SITE PLAN REVIEW AND APPEARANCE BOARD

Dunkin Donuts

Meeting	File No.	Application Type
March 25, 2026	2024-152	Level 2 Site Plan
Property Owner	Agent	
540 West Atlantic, LLC	Mike Ventura

Level 2 Site Plan Application to revitalize the existing building at 540 West Atlantic Avenue into a Dunkin Donuts restaurant, including the addition of a 168 square foot walk-in cooler, modifications to the building elevations, and associated site improvements.

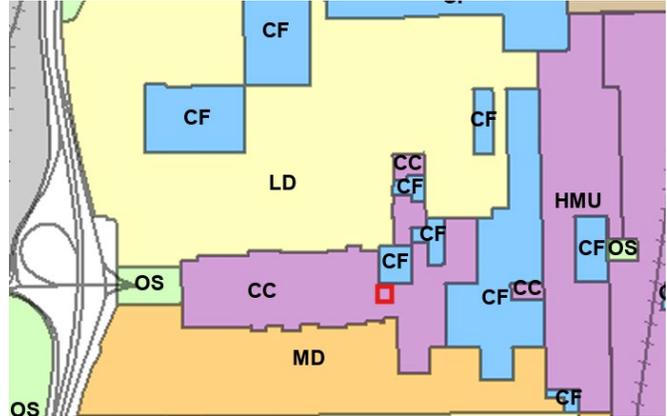
The proposed commercial development complies with the development requirements of the CBD zoning district, except for the existing non-conformities. The proposed site plan for the property was reviewed as a Level 2 Site Plan based on the scope of work

Pursuant to **LDR Section 1.3.5**, existing structures that are legally non-conforming may remain provided that alterations do not enlarge, expand, or increase the degree of nonconformity. The existing building contains a nonconforming corner setback of approximately 8 feet whereas at least 10 feet is required. The project does not alter or expand the building envelope in a manner that would increase the degree of nonconformity. Additionally, the proposed exterior renovations increase window openings along the building frontage, thereby reducing the existing nonconformity and improving consistency with the CBD ground-floor transparency standard.

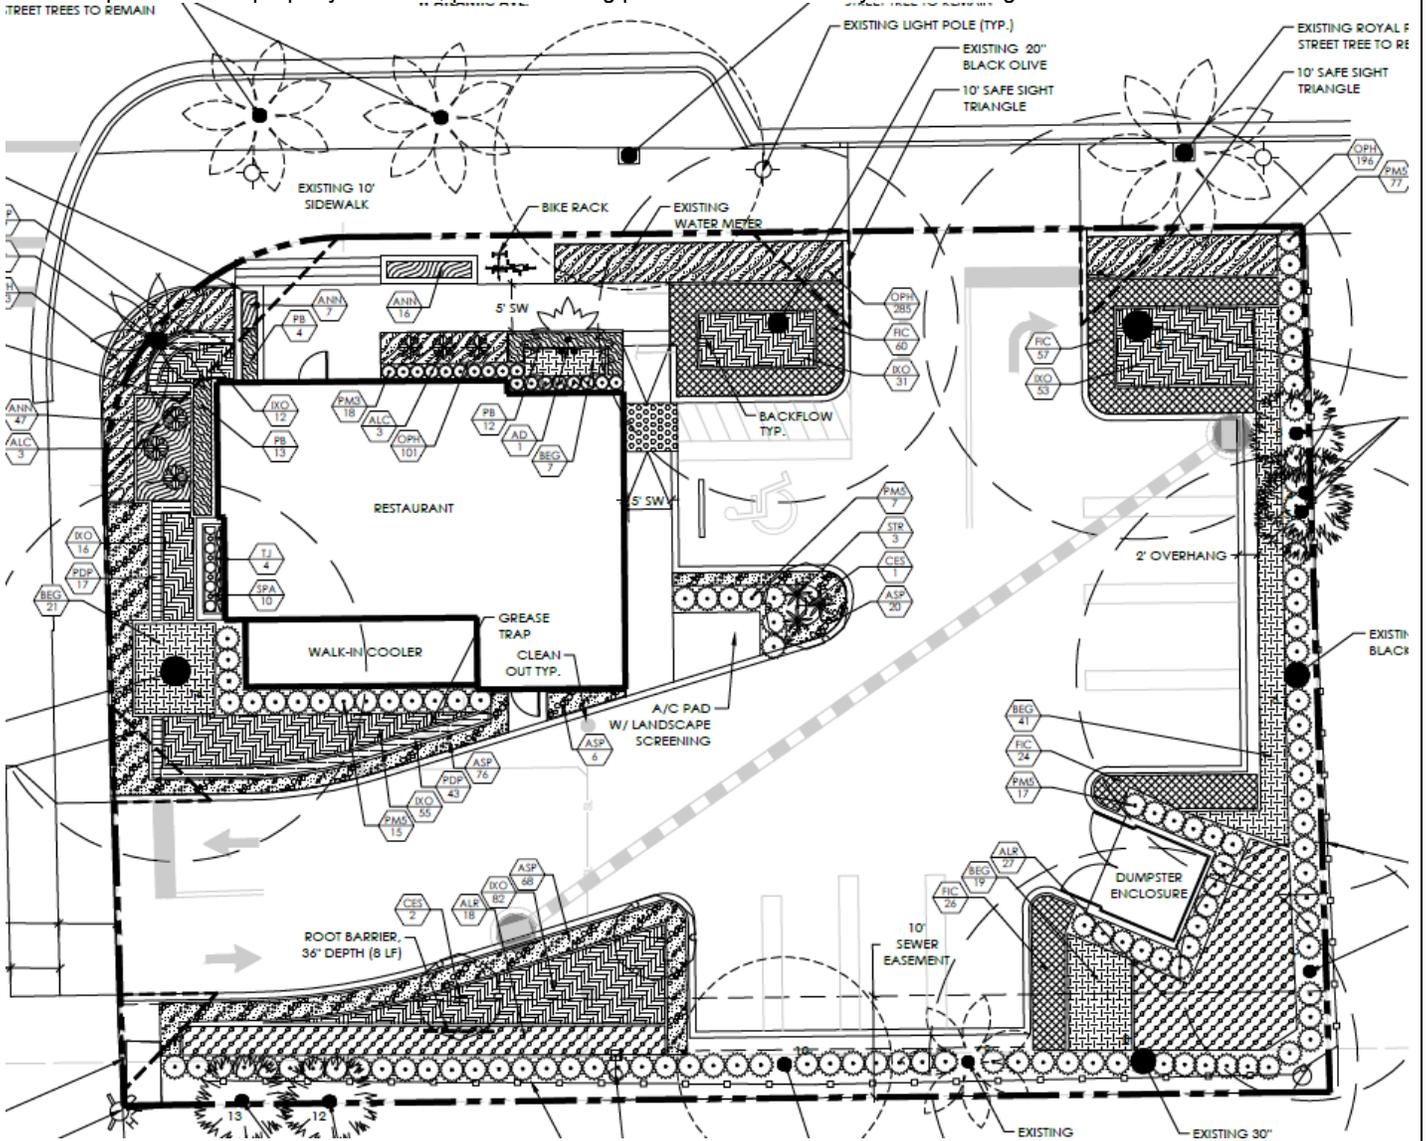
Overall, the landscape plan has been deemed technically compliant by the Senior Landscape Planner, pursuant to the applicable requirements of LDR Section 4.6.16. The applicant proposes removal of existing artificial turf area and replaces with living plant material with layered shrubs and ground cover. The proposal intends to remove one Mahogany and replace with one Silver buttonwood tree. The plan significantly improves the appearance and function of the site through preservation of existing mature trees, installation of a perimeter landscape buffer, creation of a landscaped entrance feature, installation of additional shrub and groundcover plantings, screening of mechanical equipment and dumpster area. The landscape plan proposes installation of a five-foot wide perimeter landscaped buffer along portions of the site perimeter adjacent to neighboring properties consisting of the existing mature trees and palms with layered new Yew Pine shrubs, combined with accent plantings of White Angel Begonia and Regal Shields Alocasia shrubs. A landscape terminal island is proposed at the parking lot entrance along SW 6th Avenue. The island includes canopy plantings and shrub material designed to define the vehicular entrance, meet dimensional requirements for parking lot island contributing to the reduction of the visual dominance of pavement and support the landscape objectives of Section 4.6.16(H). The terminal islands contain a Silver Buttonwood tree, and a mix of shrubs and accent plantings of Foxtail Fern and Dwarf Izora shrubs. Additional landscape is planted in areas around utilities and mechanical equipment, including screening around the A/C unit pad and grease trap. Yew Pine, Bird of Paradise and Foxtail Fern. The proposed landscape palette includes a mix of palms, canopy trees, shrubs, ornamental plants, and groundcover species. This diversity enhances site aesthetics and contributes

to a layered design consistent with the City's landscape standards. As part of the review, a 7.5-foot easement is requested along the southern portion of the property. As such, prior to building permit issuance a utility easement agreement shall be recorded.

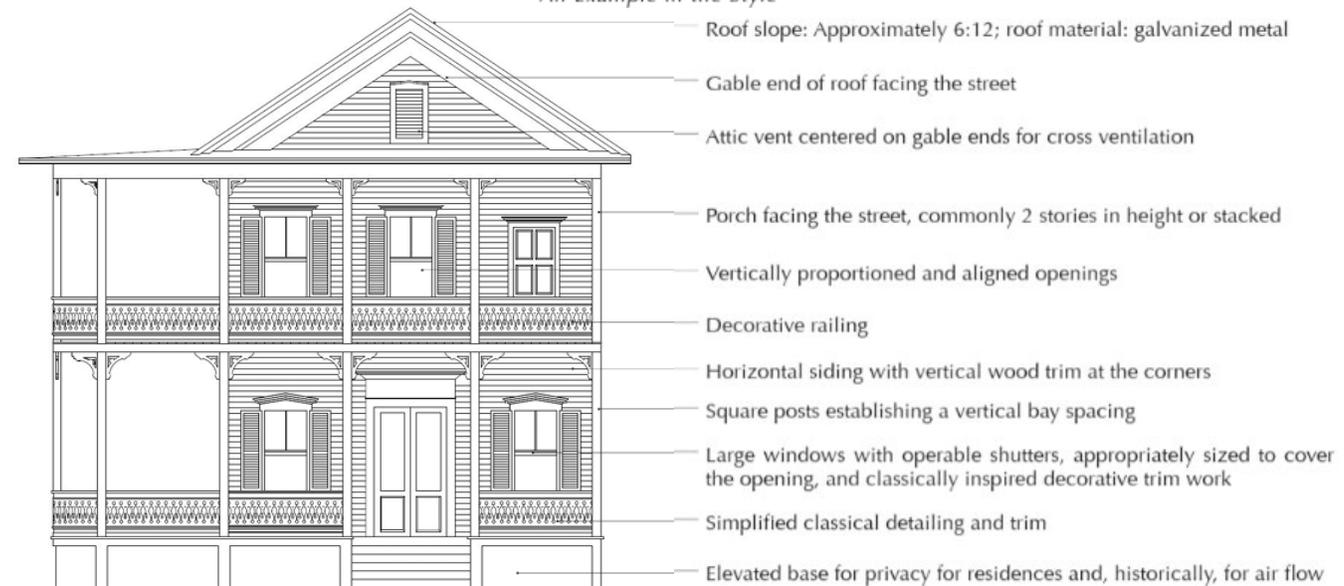
The proposed elevations provided below have been reviewed for compliance with Section 4.6.18 - Architectural Standards.

LDR 4.4.13(F)(2) - Façade Composition, Tripartite Organization: The building elevations demonstrate articulation through a central tower emphasizing the primary entry, the changes in roof form and building height, and variations in materials and fenestration patterns. These features break up the horizontal mass of the building and create visual hierarchy consistent with CBD design standards. The design features a clear division of base, middle and top façade composition. The base features a smooth, light grey stucco finished, while the primary wall plane include horizontal lap siding and fenestration. The top is defined by the gable form and metal roof, providing visual termination to the building elevation.

LDR 4.4.13(F)(3) - Architectural Style, Florida Vernacular: The proposed elevations incorporate elements of Florida vernacular architecture, including gable roof forms, standing seam, metal roofing, and horizontal lap siding, which contribute to a pedestrian scaled façade and support the architectural character encourage within the Central Business District. The architectural elements are consistent with the defining characteristics of Florida Vernacular architecture as described in the CBD Architectural Design Guidelines and reflected in the applicant's architectural narrative and supporting renderings.

LDR 4.4.13(F)(4) - Walls and Primary Materials: The proposed elevations introduce a combination of horizontal lap siding and stucco finishes to create variation in texture and visual depth across the building façade. The lap siding used on the upper façade area reinforces the Florida Vernacular style while the smooth stucco along the portions of the building to provide contrast and maintain material continuity with surrounding commercial structures in the area. The façade incorporates fenestration framed within the façade composition and aligned with the architectural rhythm of the building, helping establish proportional balance across the elevation.

LDR 4.4.13(F)(6) - Roof Form and Screening: The building utilizes a sloped hip roof form and prominent tower with gable roof form cap utilizing a standing seam metal roof material which is historically consistent with Florida Vernacular architecture.
